Index 102-625 Temporary Road Closure

Sheet 1: Revised and Consolidated Details; Revised Notes; Deleted 'Buffer Space' and 'Distance Between Signs' Tables (Moved to 102-600); Deleted Conditions; Renamed Index.

LAST REVISION 11/01/20	REVISION	DESCRIPTION:		FY 2021-22 STANDARD PLANS	TEMPORARY ROADWAY CLOSURE	INDEX 102-625	SHEET 1 of 1
---------------------------	----------	--------------	--	------------------------------	---------------------------	------------------	-----------------

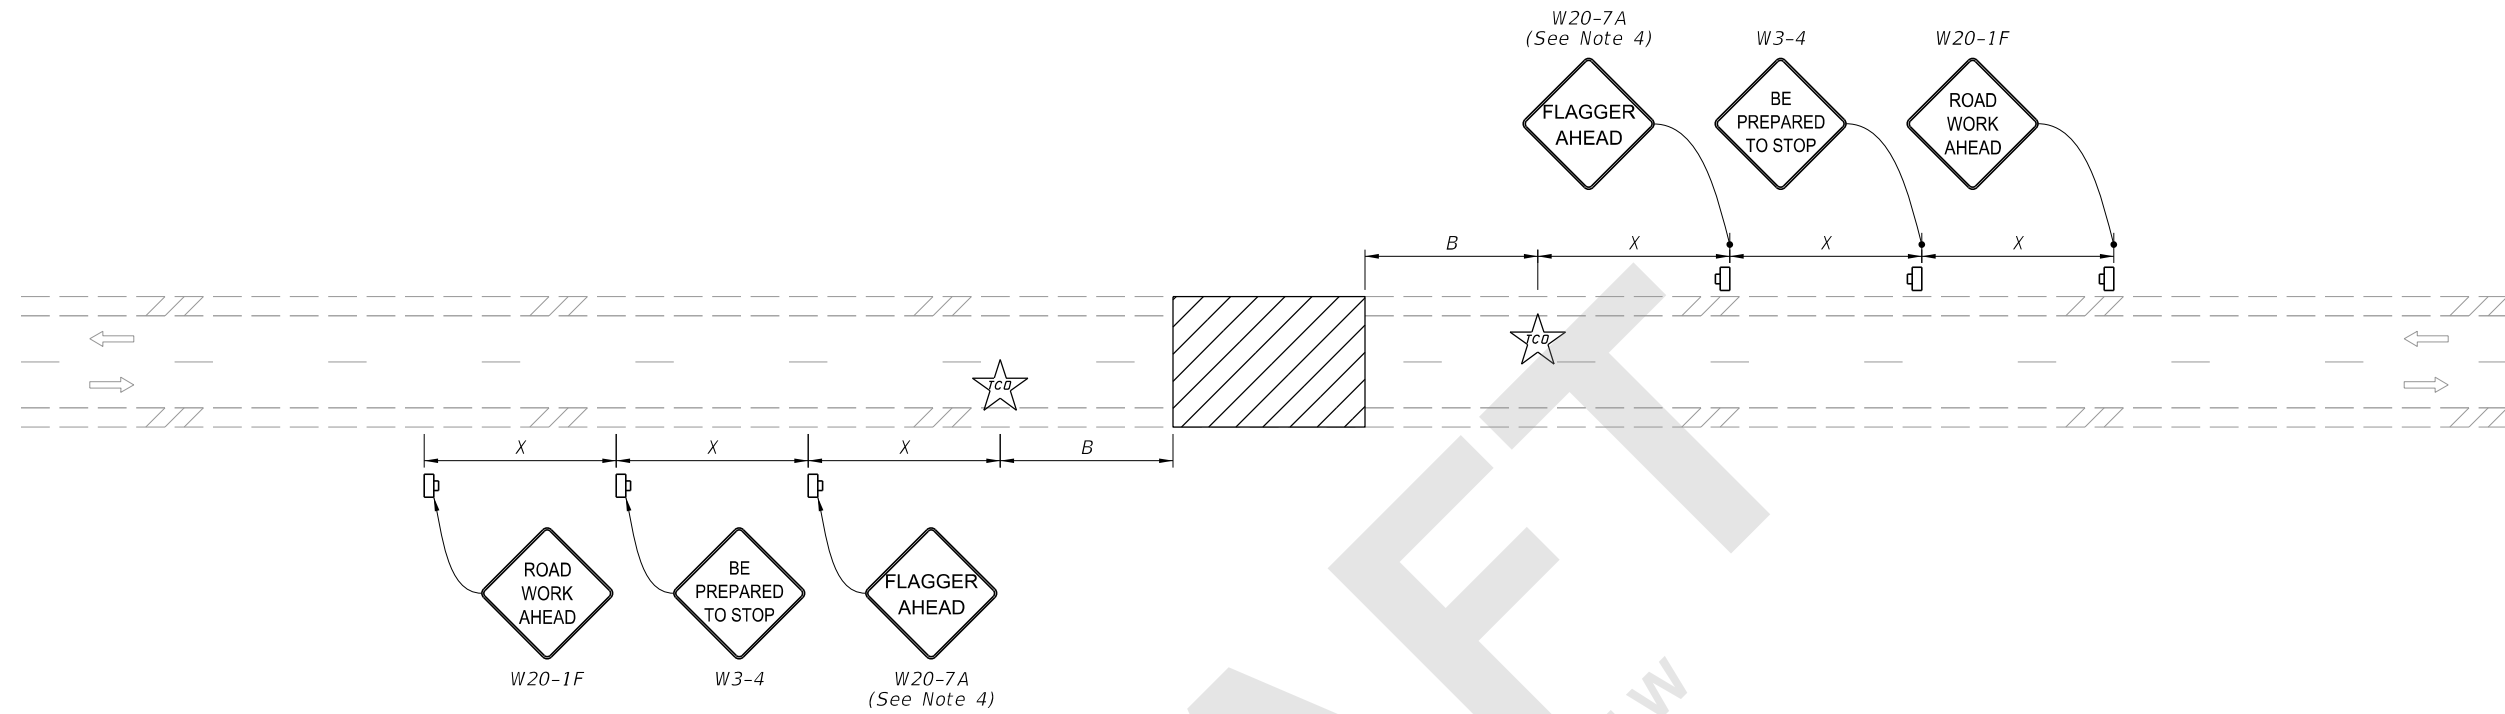
COMMENT: A note should be included to indicate that the signs need to be in both sides of the road on a divided multi-lane facility.

RESPONSE: *Agreed.*

Change Made: *Added Note; "5. Dual signs are required for divided roadways."*
